CITY OF
Albuquerque
Public Works Department

RE: REVISED DRAINAGE PLAN FOR SPORTZ OUTDOORS (F18-D27) ENGINEER'S STAMP DATED 3/10/97 AND SUPPLEMENTAL INFORMATION PROVIDED ON APRIL 1,1997

*RE: SPORTZ OUTDOORS (F18-D27). GRADING AND DRAINAGE PLAN FOR BUILDING PERMIT APPROVAL. ENGINEER'S STAMP DATED 3-10-97.*

REF: GRADING AND DRAINAGE PLAN FOR GERMERS CLOTHING RETAILER (F18-D27)
RECEIVED JUNE 27, 1984

PROJECT SPORTZ OUTDOORZ
SUBJECT DRAINAGE POND SEC.
BY RM DATE 1 APR 97
CHECKED _____ DATE _____
SHEET 1 OF 1

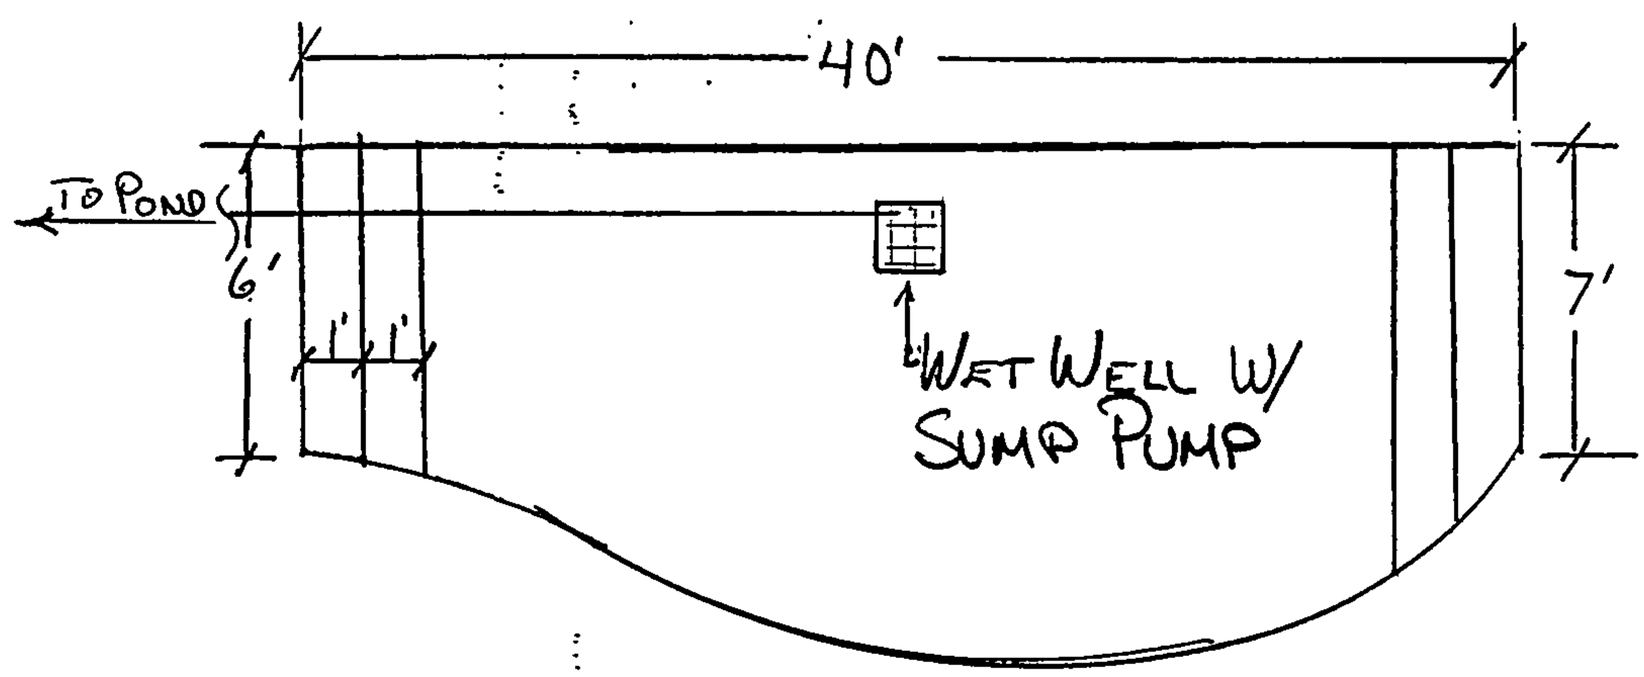
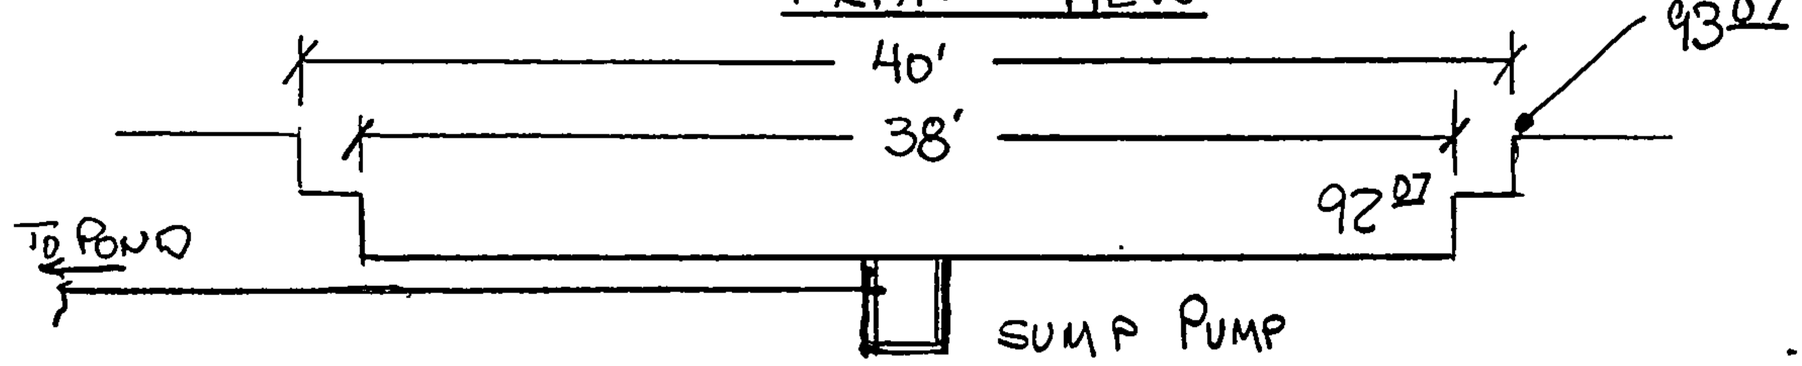
2. Provide pond volume capacity calculations and relate to proposed total volume.

*2. Provided within this submittal.*

POND VOLUME REQ'D = 418 ft³
POND VOLUME PROVIDED = 425 ft³

SECTION for OVER FLOW

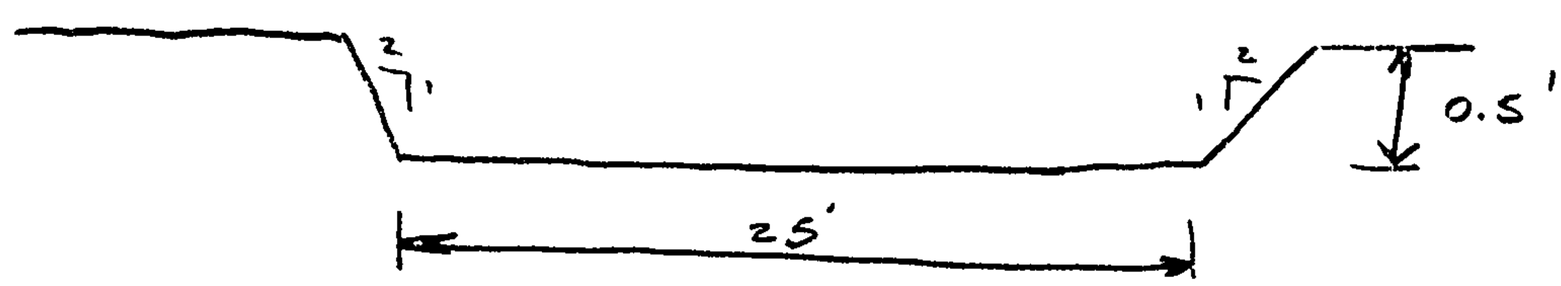
6. Details for the spillway should be provided on the plan to show how it is to be built.

USE 3" Plus ROCK for EROSION CONTROL for Spillway section.
